Response to Brian Butterworth

We thank the reviewer for his thorough comments. These comments forced us to investigate our measurement installation even further and revealed important insights. We reply to each comment in the following.

Fig R2. Schematics of the test setup. Dark lines represent steel pipes and light blue lines are Bev-A-line-tubings.

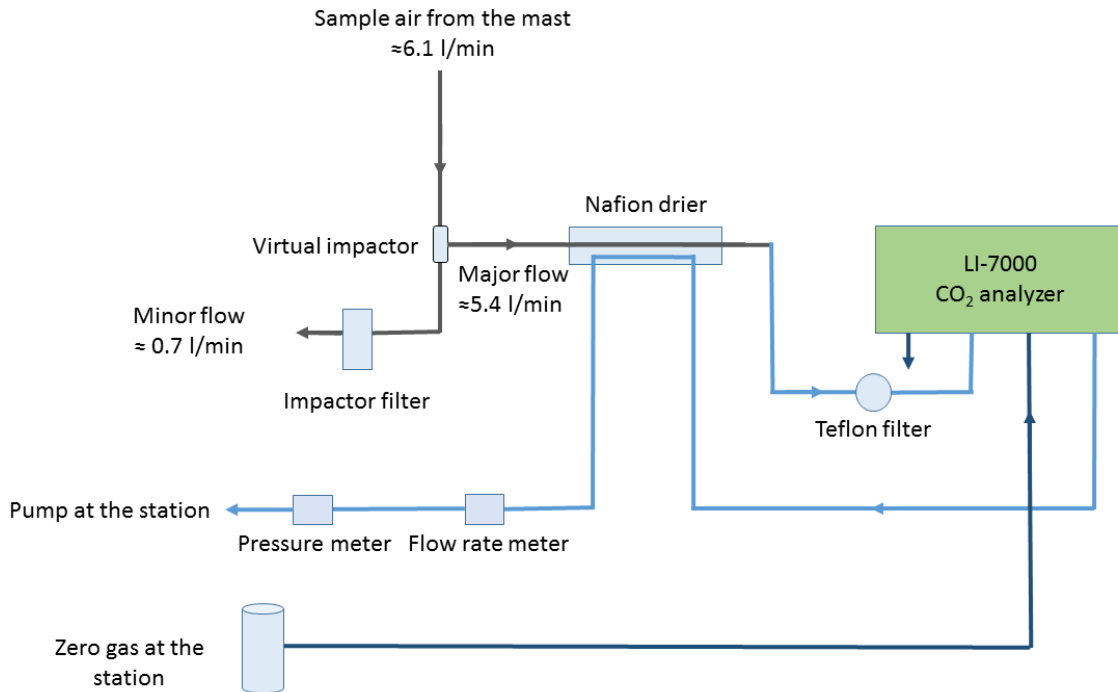
RC2.9 Page 6 – How do you generate your purge air for the nafion? And zero gas for the LI7000?

The same sample air coming from the gas analyzer is directed to the outer cell of the drier. Thus, the total pressure difference drives the water vapor removal. This indeed does not remove all water vapour but effectively attenuates the fluctuations, as shown by the H₂O variances. Please see the figure below.

Sentences were added to the page 6 line 9:

The sample air leaving the gas analyzer of the test setup is directed to the purge cell of the drier. Thus, the total pressure difference drives the attenuation of water vapor fluctuations.

Sentences were added to the page 6 line 17:

The same zero gas flows through both analyzers. The actual zero gas bottle (40 l) is located at the station, and a small stream of zero gas flows continuously to the gas analyzers in the instrument hut.
